Subject: Request for Modification to Individual Section 404 Permit and Section 401 Water Quality Certification for U-2579 AA and AB, the Winston-Salem Northern Beltway (Eastern Section of Future I-74), from US 311 to I-40; Federal Aid Project No. NHF-0918(14), Division 9. Debit \$570 from WBS No. 34839.3.GV5.

The purposes of this modification are as follows:

| REV. SHEET NO. | 5 |

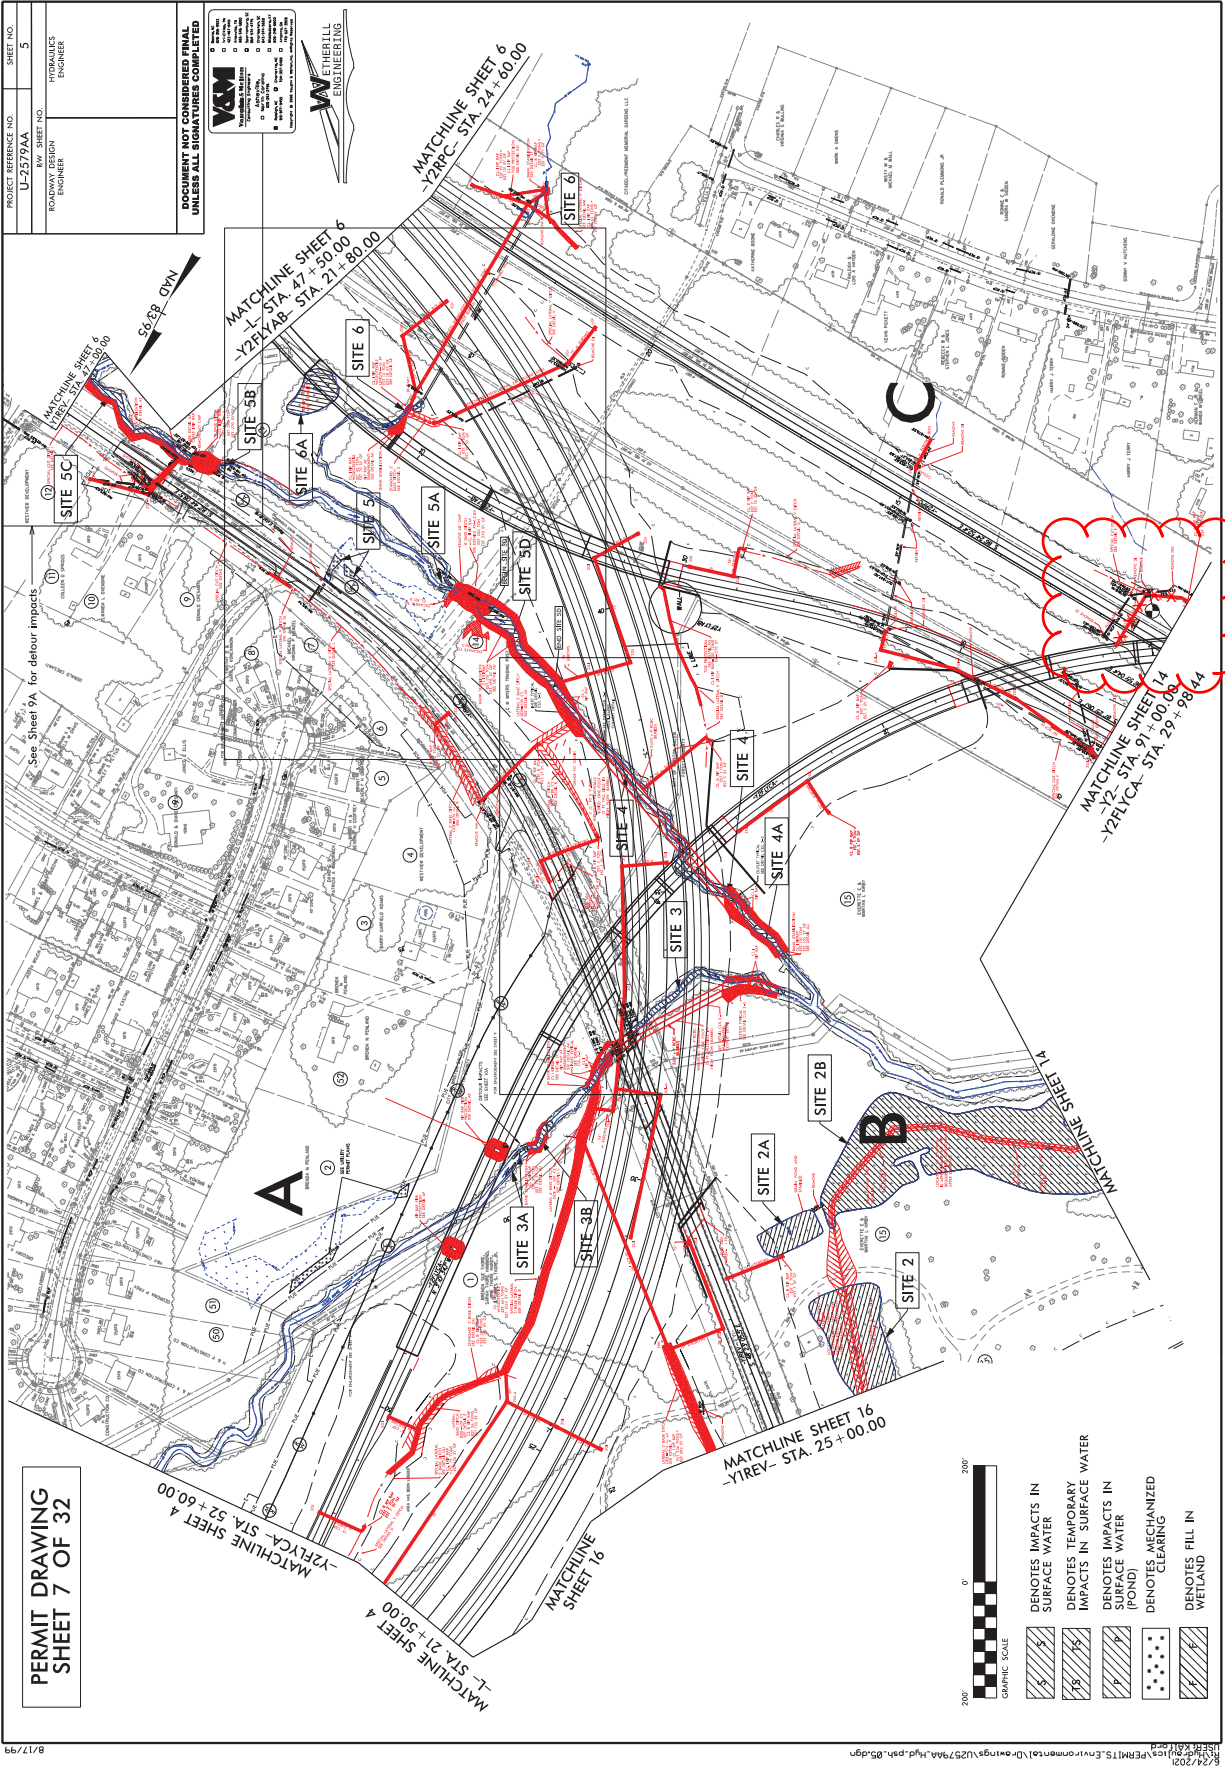
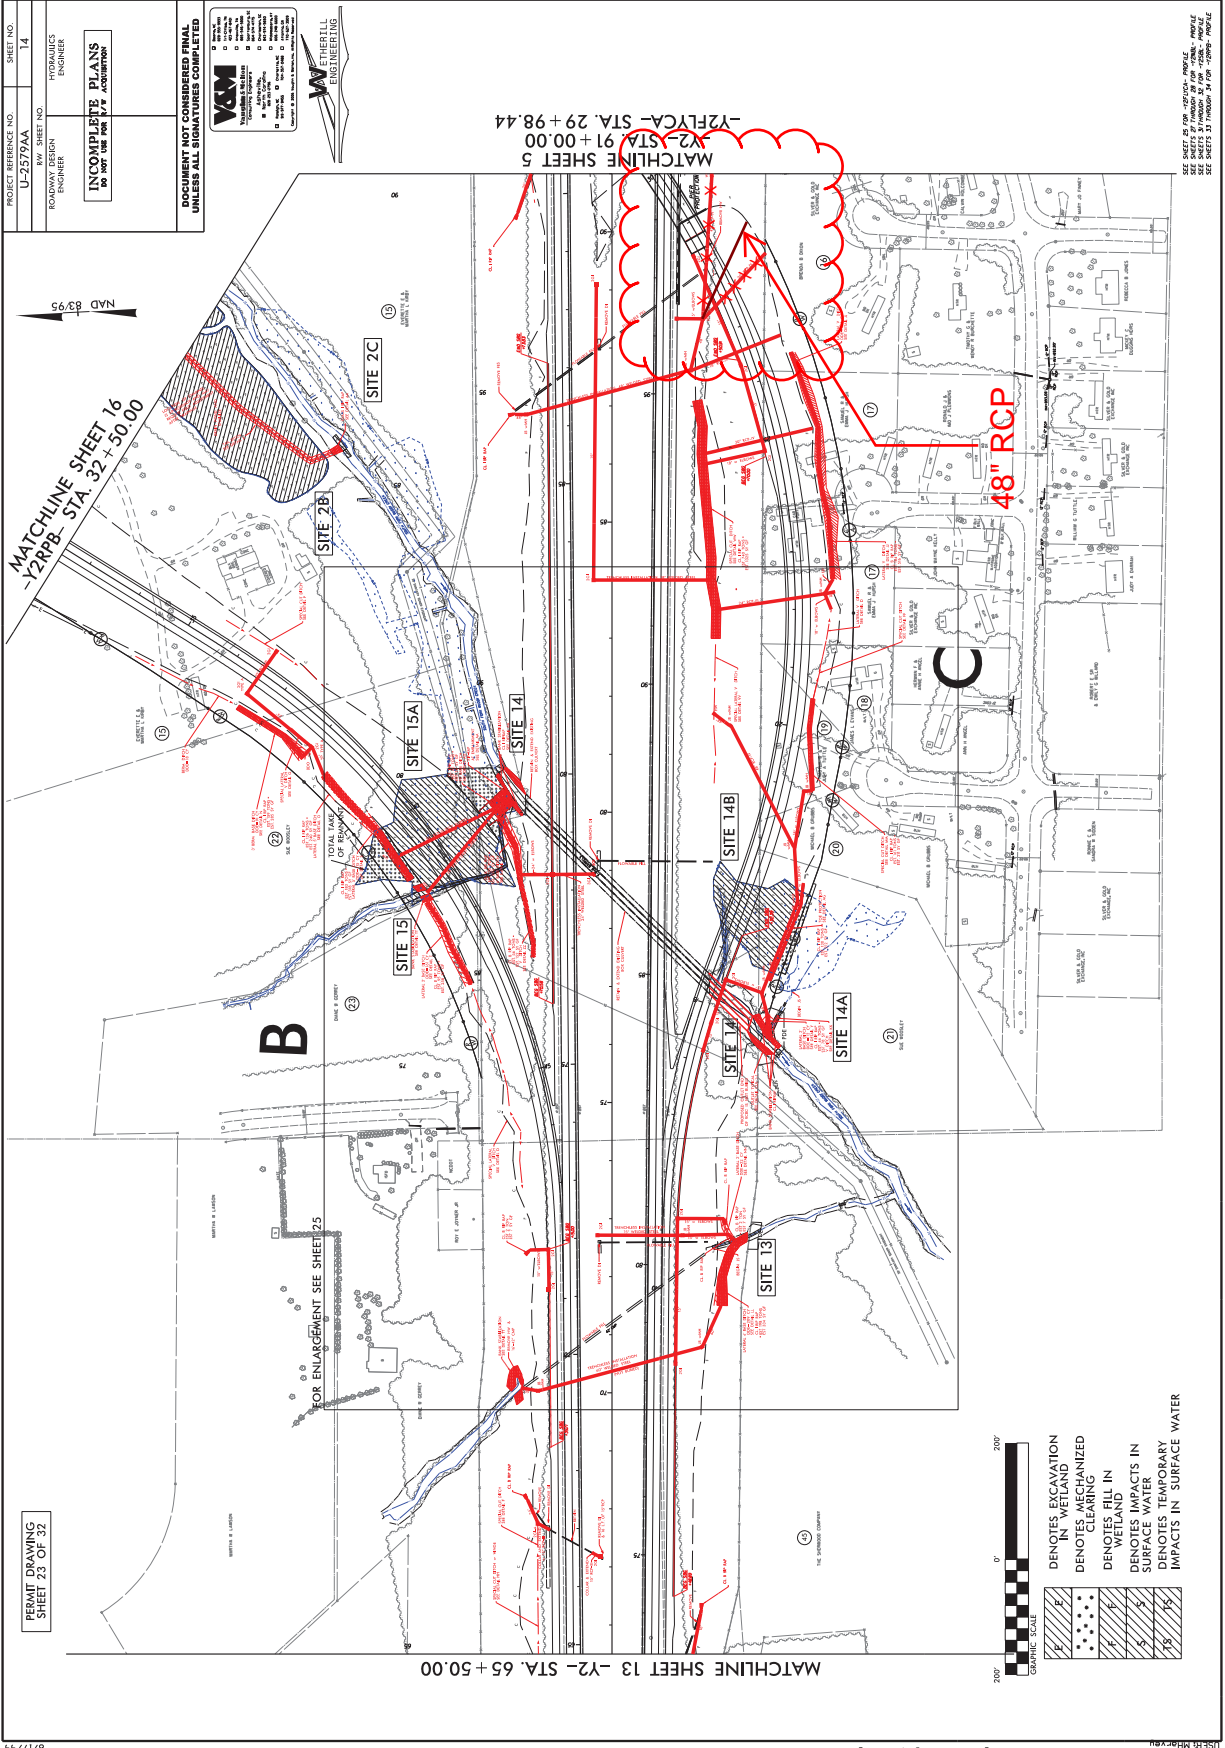
- b. Plan sheets 5 and 6 stormwater revision: the stormwater system has been revised by removing a proposed pipe system and allowing the stormwater to flow into a ditch and the crossing under the off ramp in a new 48” RCP . The stormwater will ultimately outlet at the original location at non-erosive velocities and the proposed ditches do not need to be modified to control erosion.

Stormwater revision to plan sheets 5 and 6: no changes in jurisdictional impacts.
